ISO SHT. NO. 1937

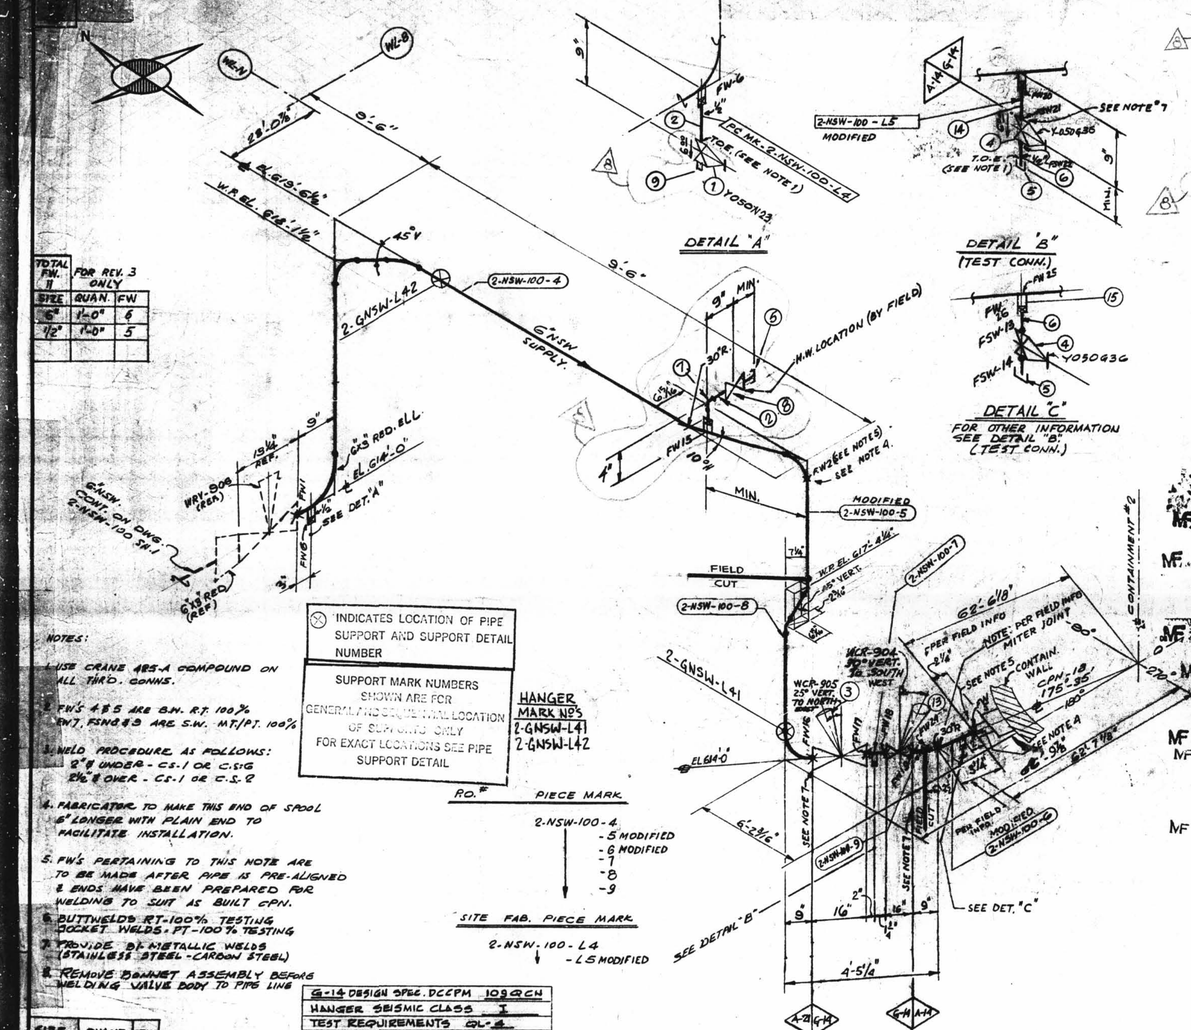
NO.	DATE	DR. CHK.	DESCRIPTION	REMARKS
1	1-20-76	DR. B.R.	REVISED BY A.E.P. DESIGN; PER RFC-DC-12-671; ADDED: 6" CHECK VALVE 15CE062A, 1" VENT-VALVE No. Y-100T23, 1/2" DRAIN-VALVE No. CY-050T36	ACTION REQ'D.
2	2/1/78	GP LB	PER RFC-12-, ADD DELETED VALVE TAG NO. C15CW062A & ITEMS 3 THRU 12 AND REVISED RELATED PIPING	FIELD ACTION REQ'D
3	9/14/81	K.A. D.R.	PER RFC-DC-12-2549 ADDED: PIPE SPEC. G-14, DIM'S, PCMK #7, FIELD WELD BOX, NOTES: 6, 7, 8, FW 16 TO 20, FSW 21 & 22, ITEM NO'S 13 & 14 TO B/M, DELETED ITEM NO'S; 7, 9, 10, 11 & 12 FROM B/M, REVISED ITEM No 3 B/M, MODIFIED PC. MK. 6 & L5.	FIELD ACTION REQ'D
4	10/14/81	K.A. JM	PER RFC-DC-12-2549 ROTATED ACTUATOR OF VALVE WCR-904 TO 25° VERT TOWARD SOUTH-WEST, REVISED DIM'S, ADDED DIM. 62'-7⅛"	FIELD ACTION REQ'D
5	6/4/82	KA 82	PER RFC-DC-12-2549 REVISED PIPING & DIM'S, RELOCATED TEST CONN. ADDED: FW'S 28, 29, 30, 31, 32, 33, 34, 35, 36, PC.MK. 2-NSW-100-8-5, ITEM 15 TO B/M MODIFIED PTO PC.MK. 2-NSW-100-8 & 5, ROTATED VALVE WCR-905 25° TO NORTH, REVISED & INSULATED PIPE WCR-905 & ROTATED 25° VERT. TO SOUTH-WEST, ADDED 30° ELBOW, 25° VERT. TO SOUTH-WEST, FW'S 5 & 6 SHOULD BE 2" & 3"	FIELD ACTION REQ'D.

6	7/21/82	HE JM	916" DIM. WAS 8'-6", 23'-0 7/8" WAS 23'-0", 62'-6 7/8" WAS 62'-7 7/8" TYPE CHANGES ARE DUE TO RE-DATING BASIC ON LATEST DWG. CHANGES	NO FIELD ACTION REQ'D.
7	8/11/86	DK. DRAWN LB	PER RFC-DC-12-2876 REQ'D - ITEM 8, TYPE OF VALVE. ADDED SUPPORT DETAILS, SUPERSEDED HGR 150 2-GNSW-100 SHT 2. ALL ABOVE TO REFLECT AS-BUILT CONDITIONS.	NO FIELD ACTION REQ'D.
8	7/21/90	FRB DCM LB	TO REFLECT AS-FOUND CONDITIONS FOR RFC-DC-12-3010 PER FWR # 759 REV. 1. ADDED: PLUG & ITEM # 1 & 9 ON B/M. REVISED: 1" VENT CONFIGURATION & B/M ITEM #1. ADDED: SUPPORT MARK NOS. & SUPERSEDES HGR. 150 NO. 2-GNSW-100 SH. # 2.	NO FIELD ACTION REQ'D.
